CITY OF ALBUQUERQUE

RE: **Lot 1 Block 2 SAD 228**
8024 Canoncito Dr. NW
Volcano Cliffs Subdivision
Grading and Drainage Plan
Engineers Stamp Date 11/6/19 (D10D003C1)

GRADING AND DRAINAGE PLAN
MALDONADO RESIDENCE
8024 CANONCITO DR NW
CITY OF ALBUQUERQUE, NEW MEXICO

GRADING AND DRAINAGE - SITE PLAN

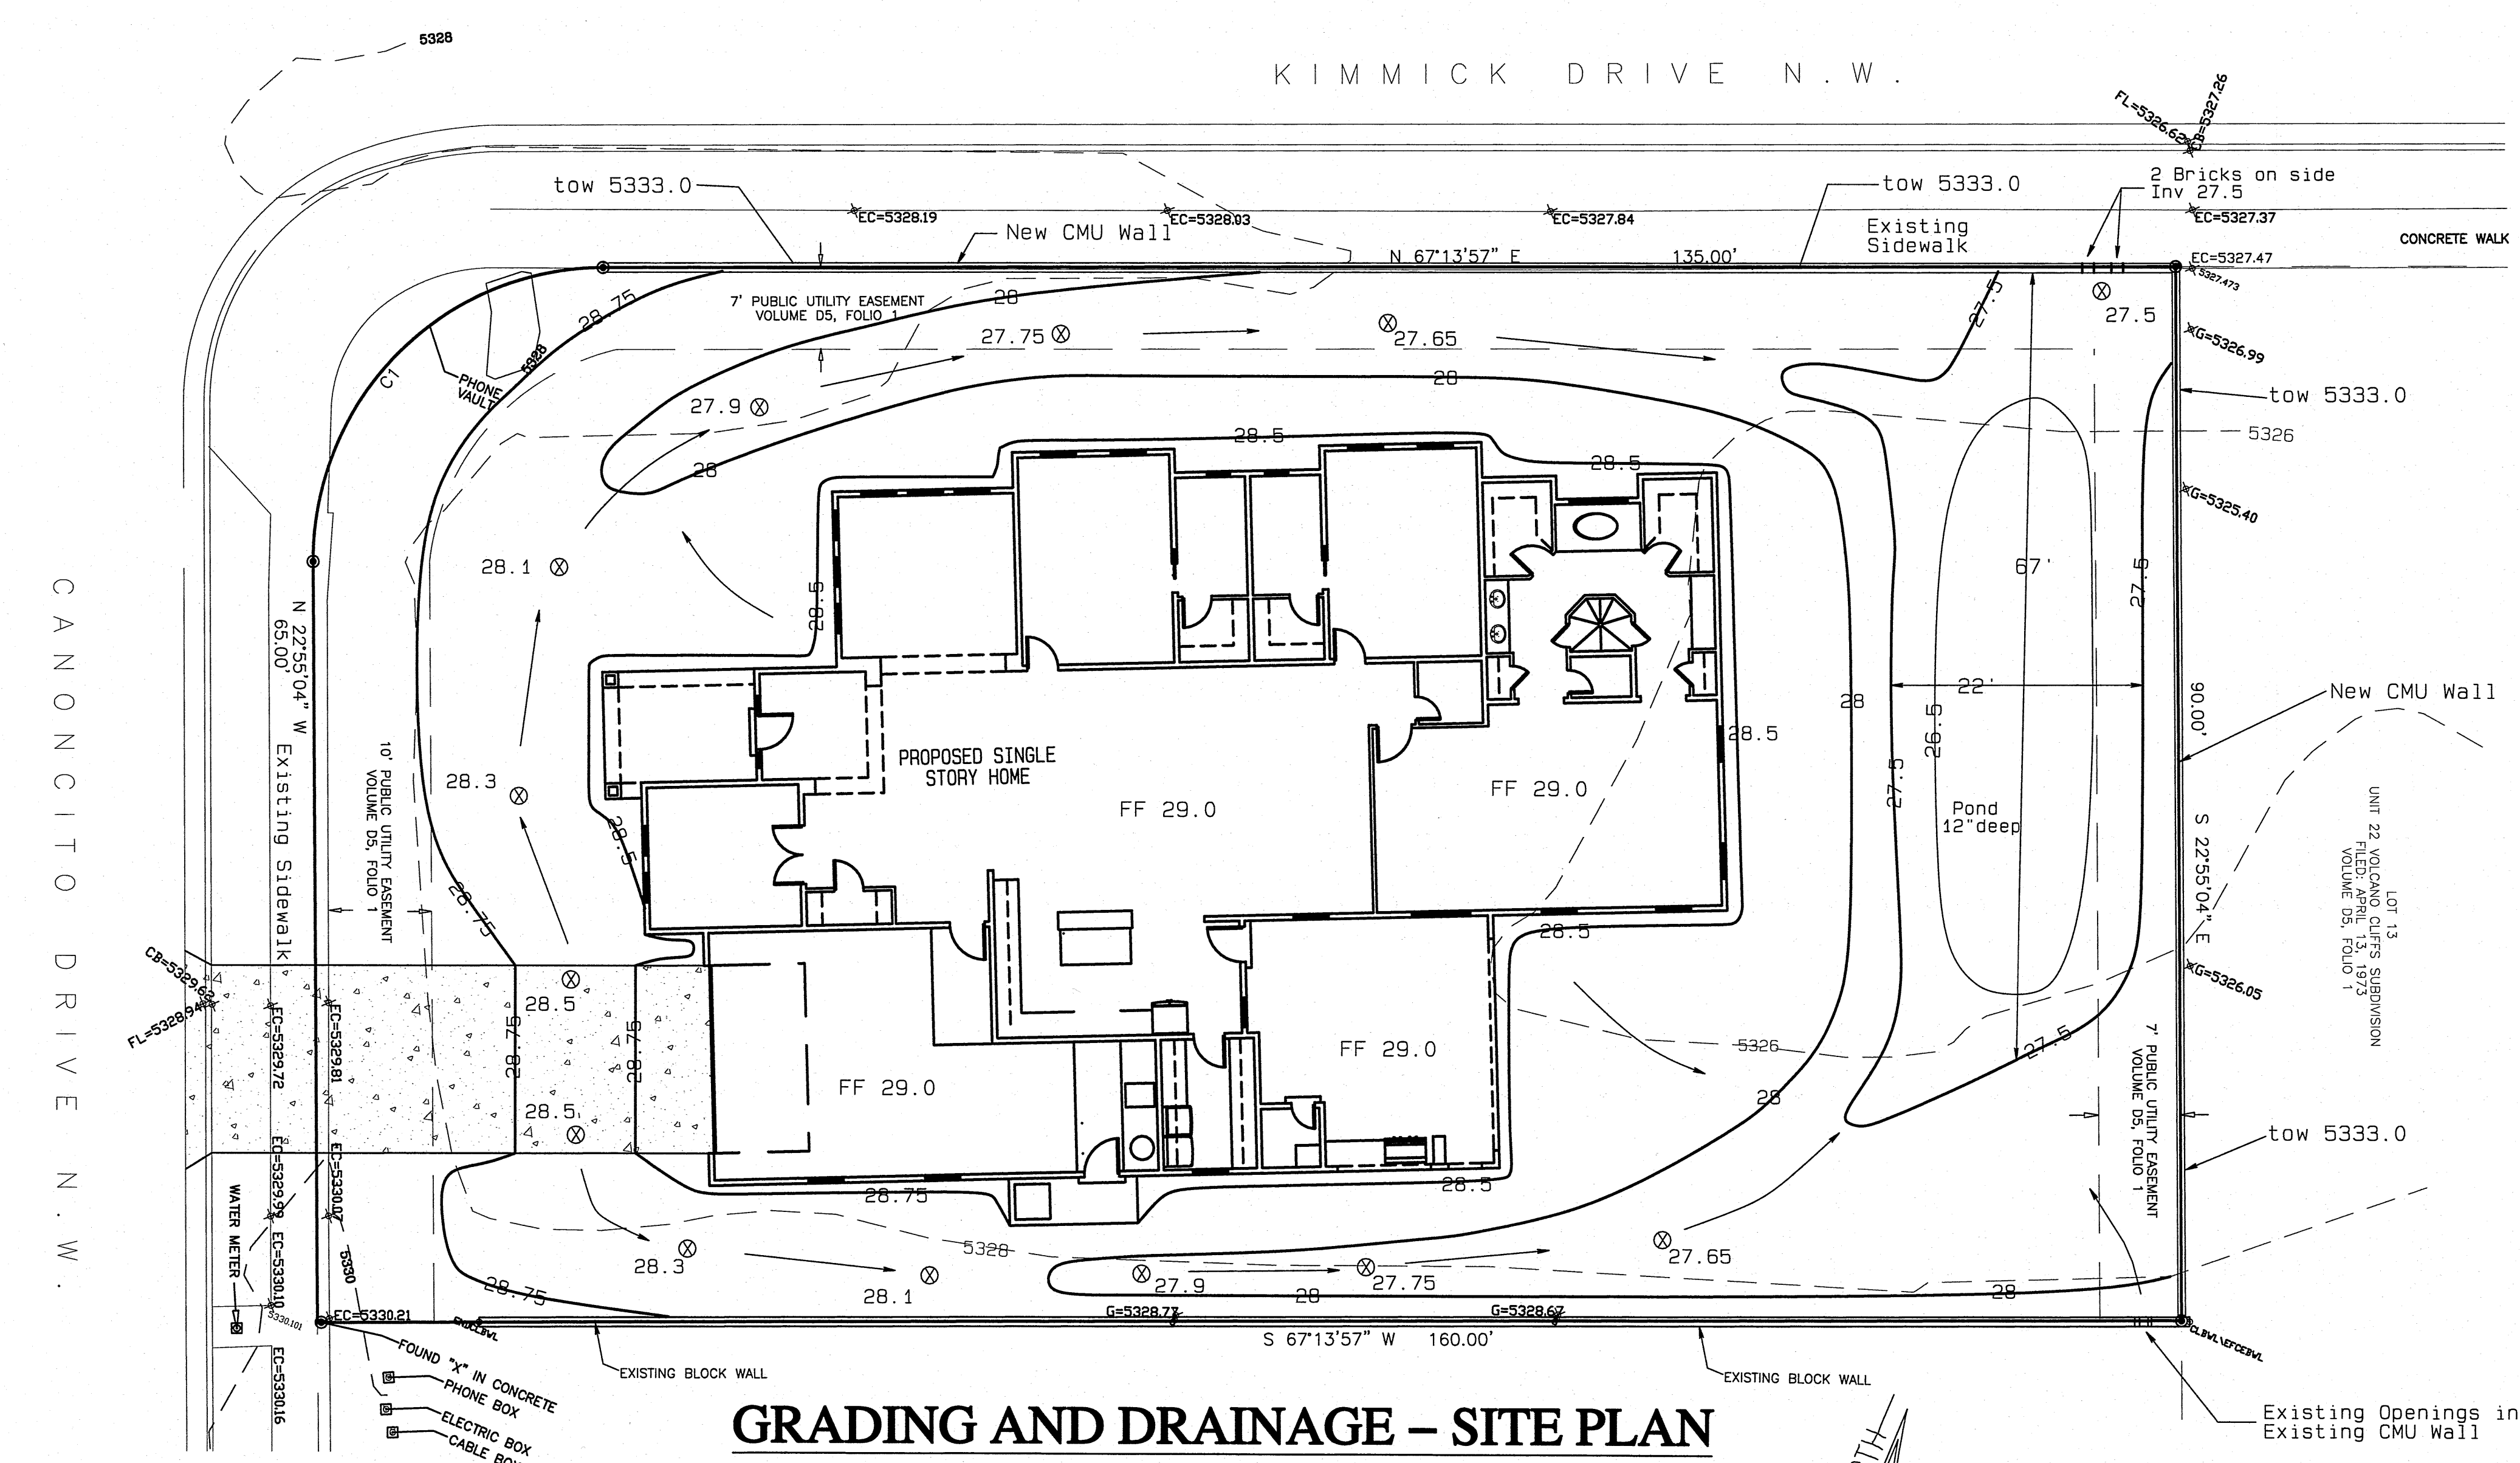
Based upon the information provided in your submittal received 11/12/19, this plan is approved for Grading.

Inform your client that a separate wall permit is required and this is the plan which should be used for a site plan.

Prior to building permit approval a pad certification will be required.

Prior to Certificate of Occupancy release, Engineer Certification per the DPM checklist of this plan will be required.
